The Boeing Company
P.O. Box 3707
Seattle, WA 98124-2207

September 8, 2017
DAT-2017-065

Subject: Formal Dispute Resolution – Ecology’s Final Decision under Informal Dispute Resolution Regarding the Upland Feasibility Study Report, dated July 20, 2017, and Written Statement of Boeing’s Position on Disputed Items for the Boeing Everett Facility

Boeing Commercial Airplanes Everett, Washington	Monitoring Well Locations	Figure 1
--	----------------------------------	--------------------

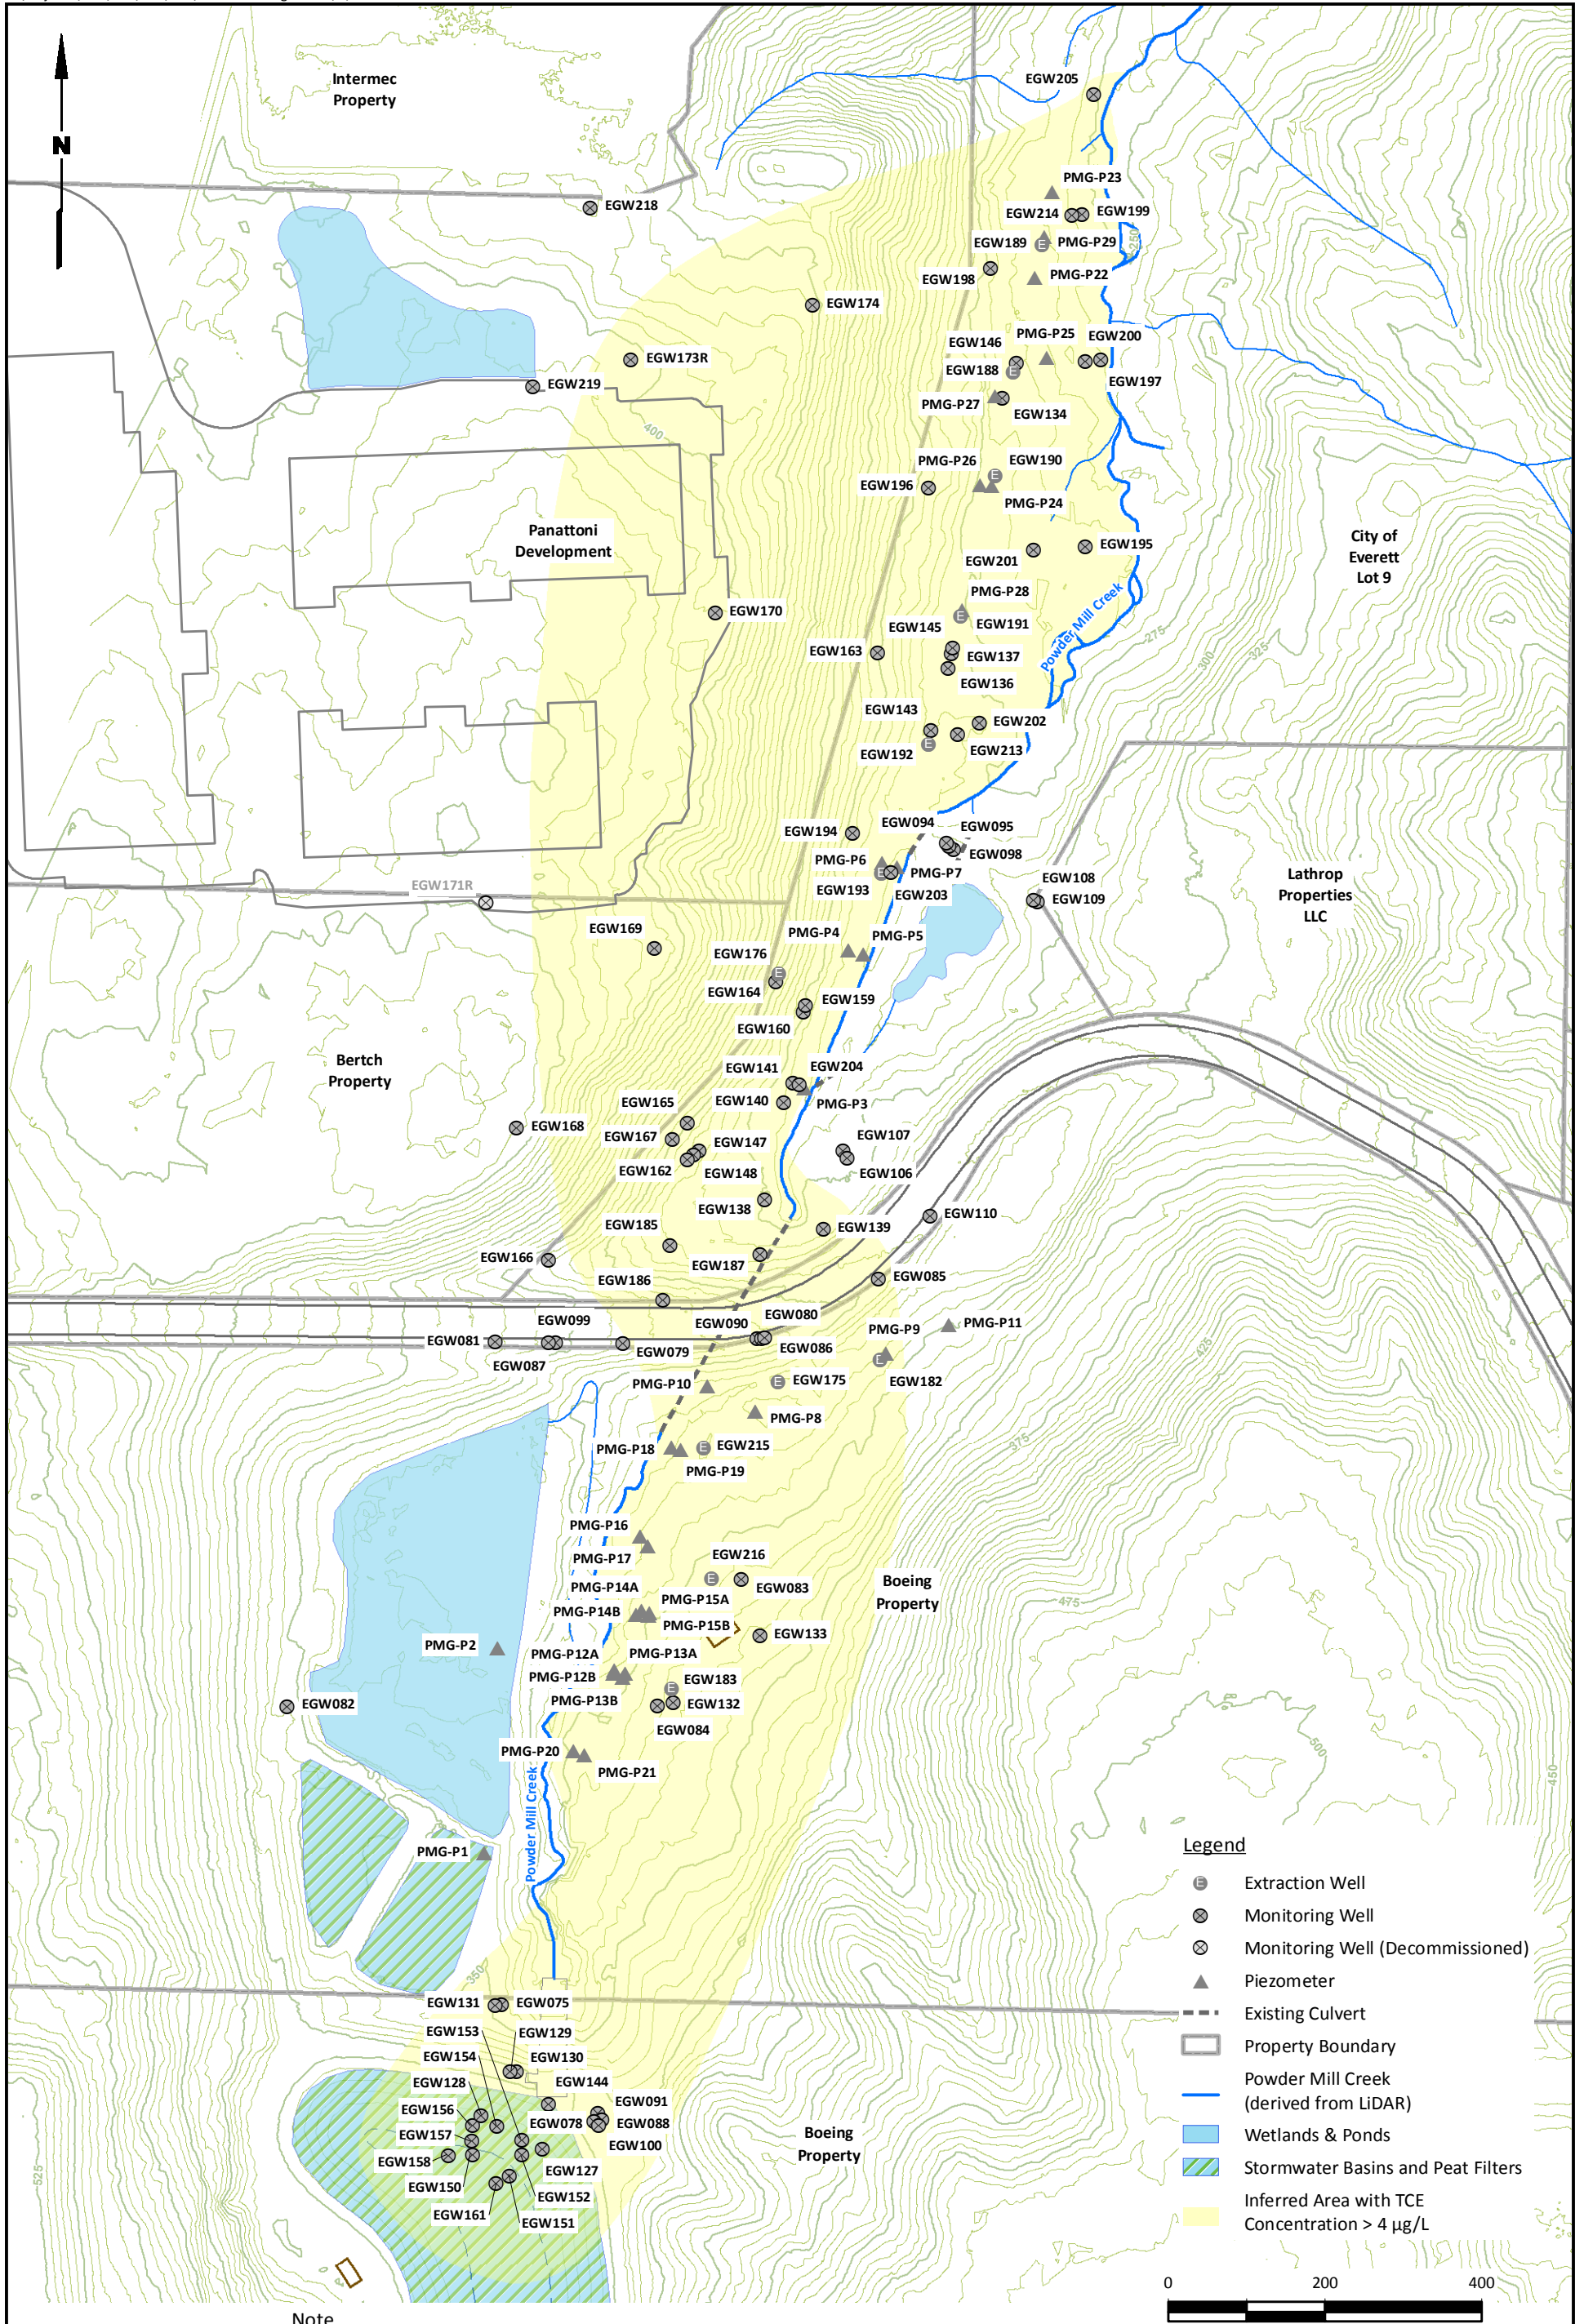
Boeing has successfully performed several interim actions (IAs) to address the 3,000-foot-long TCE plume at Powder Mill Gulch (see attached Figures 1 and 2). These IAs have included performing electrical resistance heating and supplemental bioremediation in the source area that successfully reduced TCE concentrations from over 30,000 micrograms per liter ($\mu\text{g/L}$) to less than 400 $\mu\text{g/L}$ (see Figure 3), and installation and operation of an extensive GET system in the downgradient plume that is consistently reducing the TCE levels in the Powder Mill Gulch TCE plume (from around 800 to 1,000 $\mu\text{g/L}$ in the highest concentration areas to around 300 $\mu\text{g/L}$ or less in the last 2 to 5 years; see Figure 4) and in the adjacent surface water of Powder Mill Creek (from over 15 $\mu\text{g/L}$ to less than 4 $\mu\text{g/L}$; see Figure 5). Because the performance sampling data demonstrate the success of the source area IAs and the ongoing success of the GET system in containing and reducing TCE concentrations in the downgradient plume, Boeing selected FS Alternative 1 (continued GET system operation with institutional controls and supplemental cleanup technologies, as necessary) as the preferred remedy. Although it was demonstrated as using permanent solutions to the maximum extent practicable through the MTCA Disproportionate Cost Analysis (DCA) process and it met the other applicable MTCA criteria for a final cleanup action, Ecology rejected Alternative 1. However, after careful consideration of Ecology's expectations for additional mass reduction through bioremediation, Boeing proposed performing FS Alternative 2 (source area bioremediation and continued GET system operation in the downgradient plume).

Powder Mill Gulch - TCE Concentration Maps

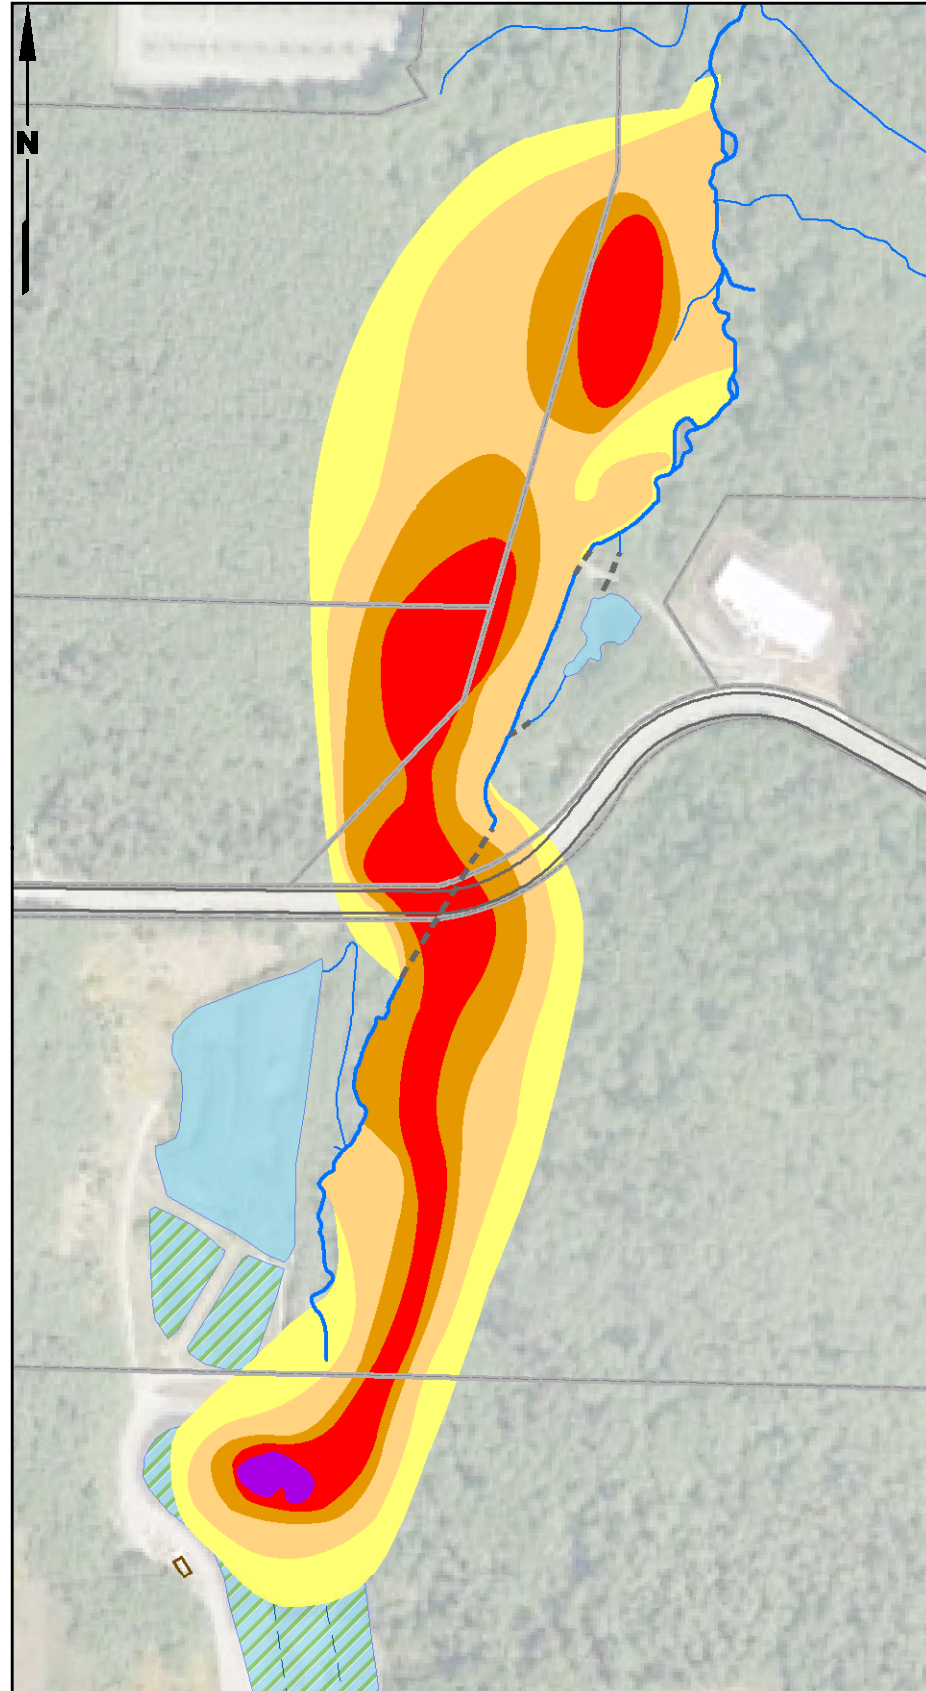
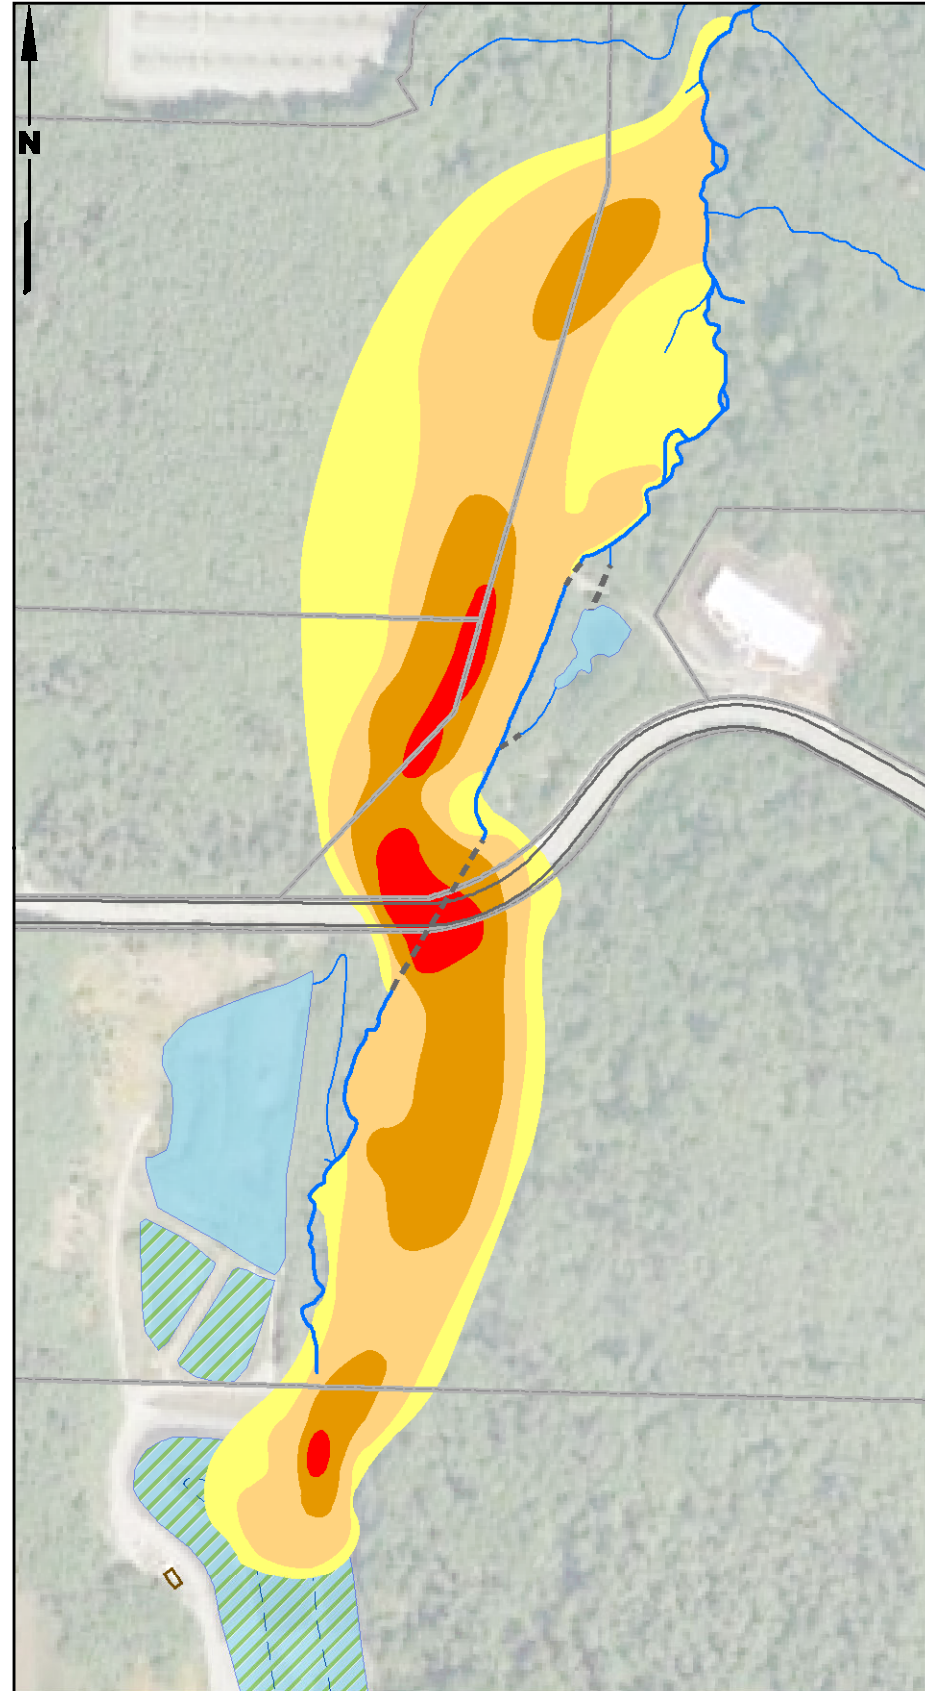
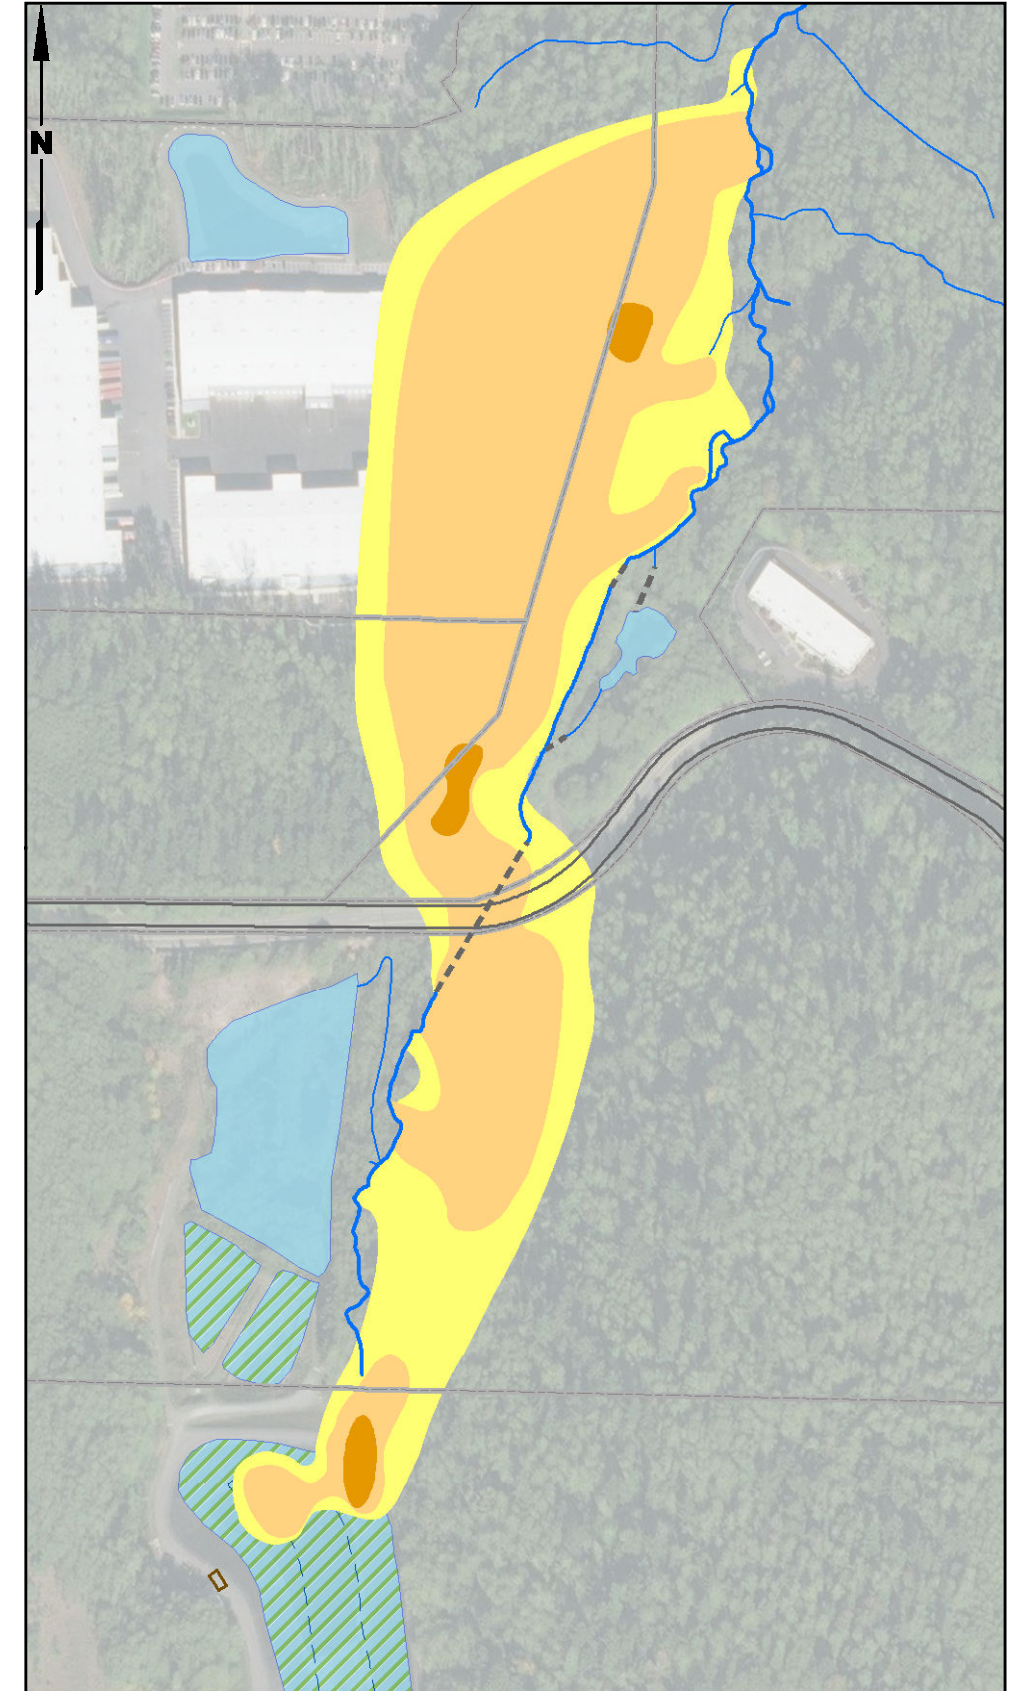
Under the Agreed Order for the site, and pursuant to Ecology approval, Boeing has successfully performed several interim actions (IAs) at PMG (see trichloroethylene [TCE] concentration maps over time on attached Figure 2), including electrical resistance heating and supplemental enhanced *in situ* bioremediation (EISB) in the source area, and installation and ongoing operation of an extensive groundwater extraction and treatment (GET) system in the downgradient plume. These source area IAs successfully reduced TCE concentrations from over 30,000 micrograms per liter ($\mu\text{g/L}$) to current concentrations of less than 400 $\mu\text{g/L}$; see Figure 3). The GET system has consistently achieved TCE concentration reductions in the downgradient areas of the groundwater plume (and surface water), including reductions in the groundwater areas with the highest TCE concentrations (from around 800 to 1,000 $\mu\text{g/L}$ in the highest concentration areas to around 300 $\mu\text{g/L}$ or less) in only 2 to 5 years¹ (see attached Figures 4 and 5). Based on the success of these source area and groundwater plume IAs in significantly reducing contaminant source mass and in containing and reducing TCE concentrations plume-wide, Boeing selected FS Alternative 1 (continued GET system operation with institutional controls and supplemental cleanup technologies as necessary) as the preferred remedy. Although Boeing's supporting Disproportionate Cost Analysis (DCA) demonstrated, under the factors in Washington Administrative Code (WAC) 173-340-360(3)(e), that FS Alternative 1 is permanent to the maximum extent practicable, Ecology rejected Alternative 1. After careful consideration of Ecology's comments in the agency's original contingent approval letter (Ecology 2016), which provided Ecology's expectation of additional mass reduction through EISB and further treatment to remove the source area as an ongoing contributor to downgradient contamination, Boeing proposed FS Alternative 2 (EISB source area remediation and continued GET system operation in the downgradient plume) as the preferred alternative.
